Project Name: Lucky's Market

Project Location: 5030 W. Atlantic Avenue Request: Class I Site Plan Modification

SITE PLAN REVIEW AND APPEARANCE BOARD STAFF REPORT

Meeting: April 10, 2019 File No.: 2019-070 Application Type: Class I Site Plan Modification

PROPOSED FRONT ELEVATION SCALE: 1/8" = 1'-0"

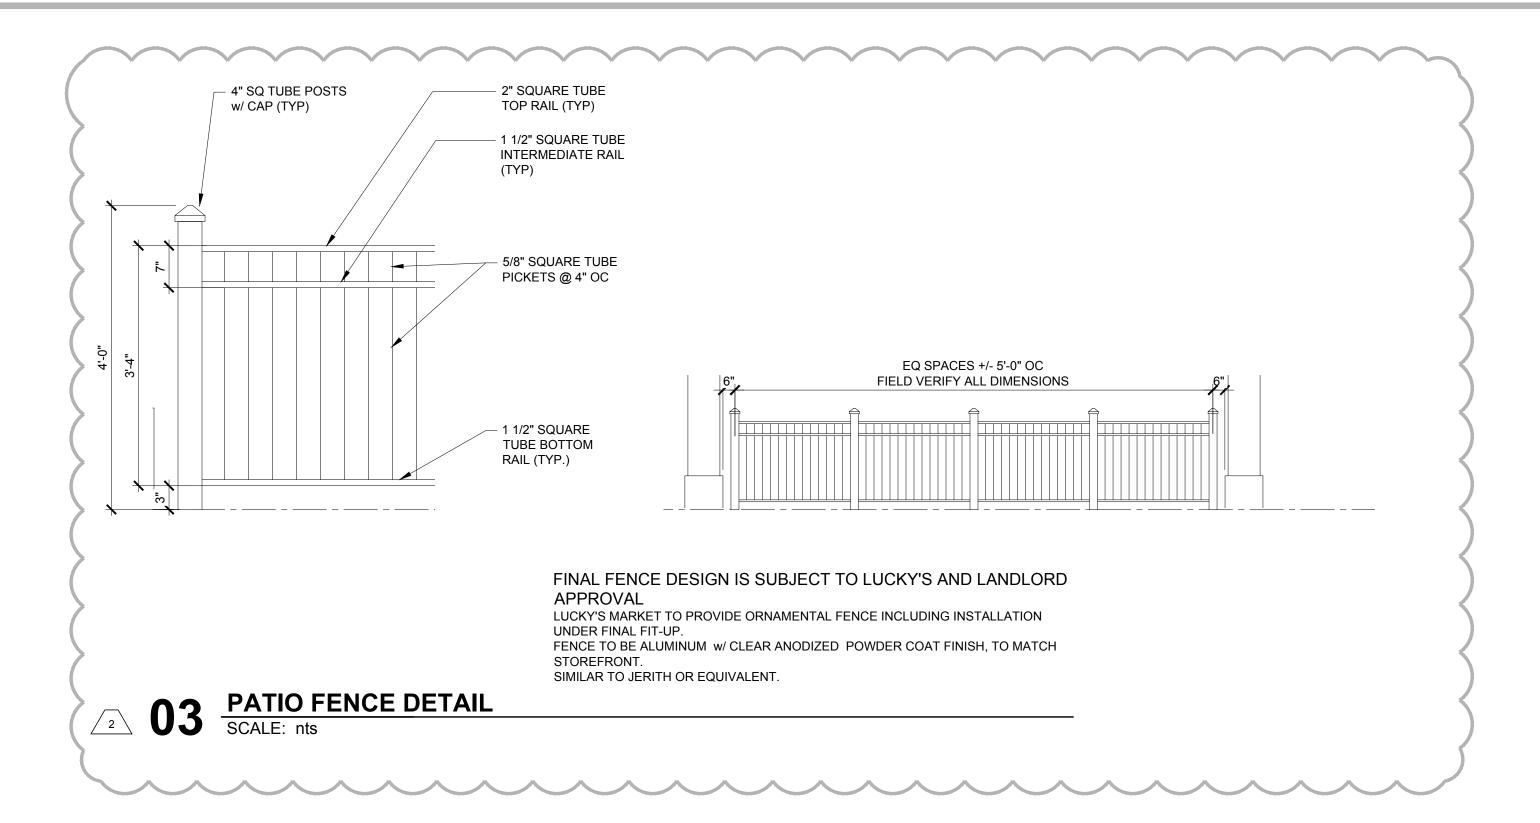
Approve with the following notes: that the photometrics meet the criteria set forth in LDR 4.6.8 prior to certification and that a note is placed on the architectural plans for the front elevation calling out the "Type D" light fixture.

- 1. That the photometrics meet the criteria set forth in LDR 4.6.8 prior to certification.
- 2. That a note is placed on the architectural plans for the front elevation calling out the "Type D" light fixture.

The front elevation is introducing lighting under the overhang and two new wall sconces centered between recess accents. Installation of two new rear wall lights and the existing dock canopy lights will remain and be refurbished with new lens and lamps. As a note, prior to certification, the site plan needs to be updated to include the lights under the canopy and the illumination foot candles must be adjusted to reflect the correct foot candles of no greater than 10 and they must be shielded.
